Elevation
 Consented Gates & Railings Design
 (Application ref 2024/2871/P)

Elevation
 Proposed Gates & Railings Design

Site Address	20 Redington Road, NW3
Project	Alterations to Garden Frontage
Drawing Title	Alterations to Gate and Railing Design
Drawing Number	D3_NMA_121
Status	PLANNING
Date	21/02/2025
Revision	
Scale	1 : 25 @ A3

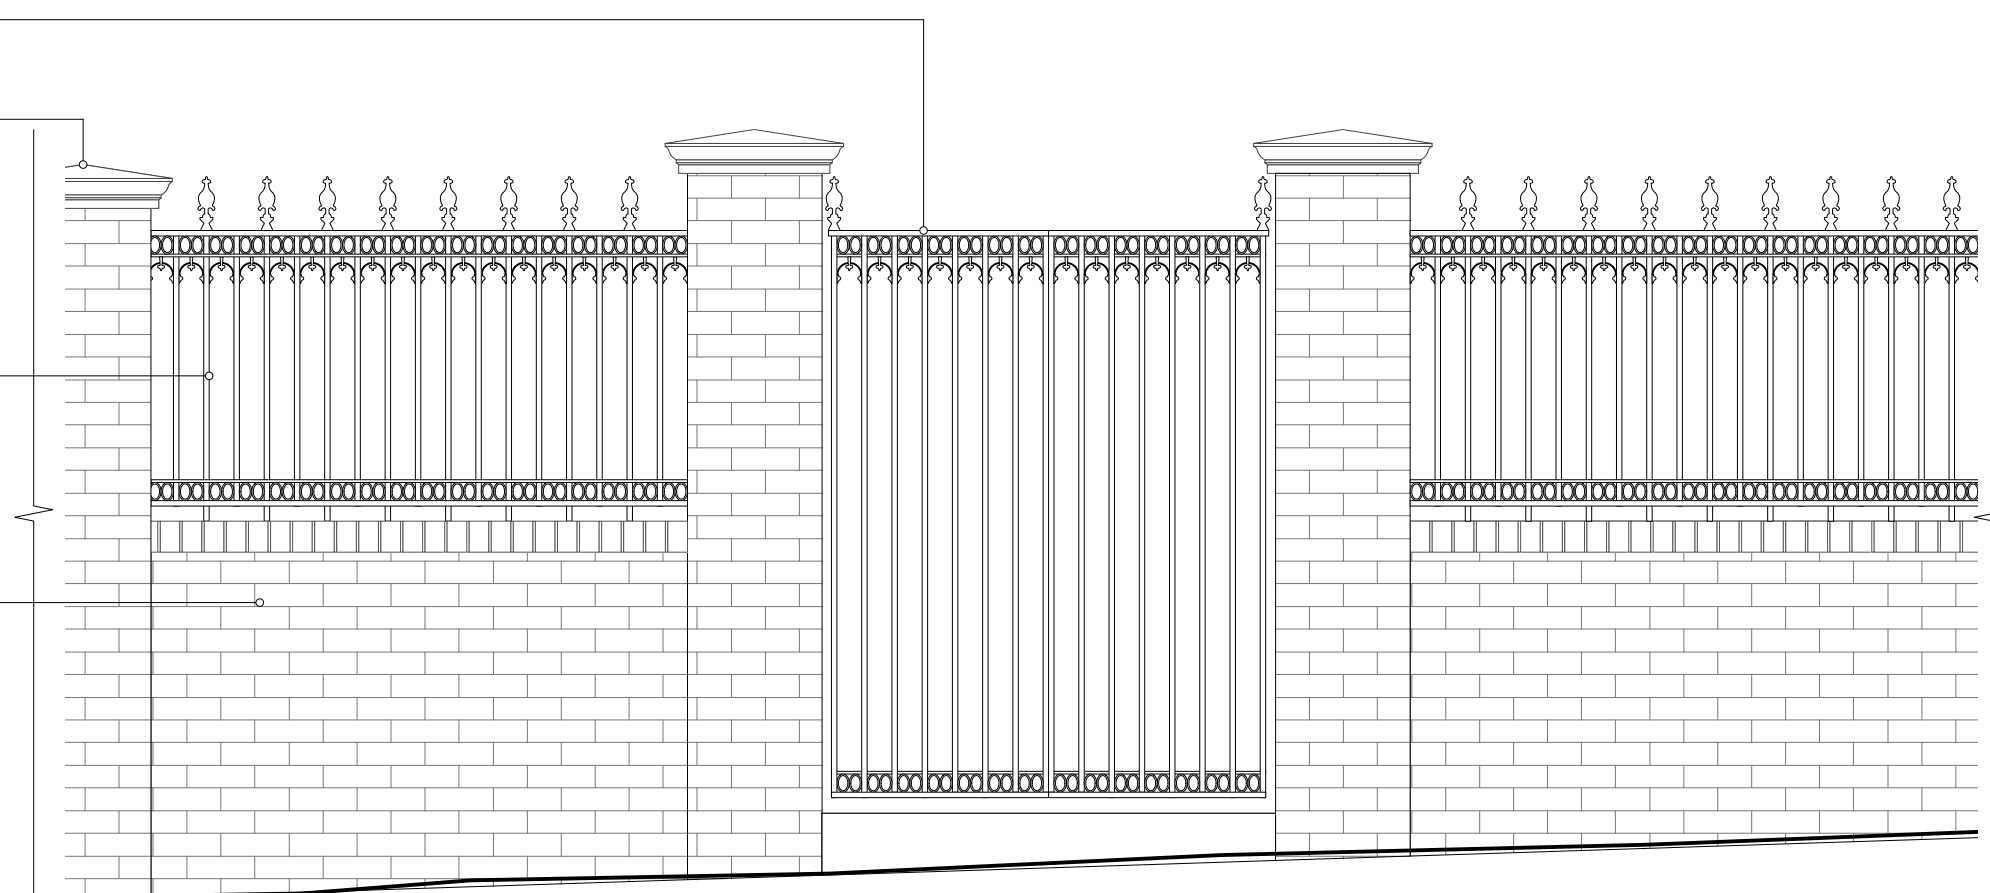
Gate consented in application 2024/2871/P proposed in steel with finial design

1150mm railings with finials over retaining wall to replace existing
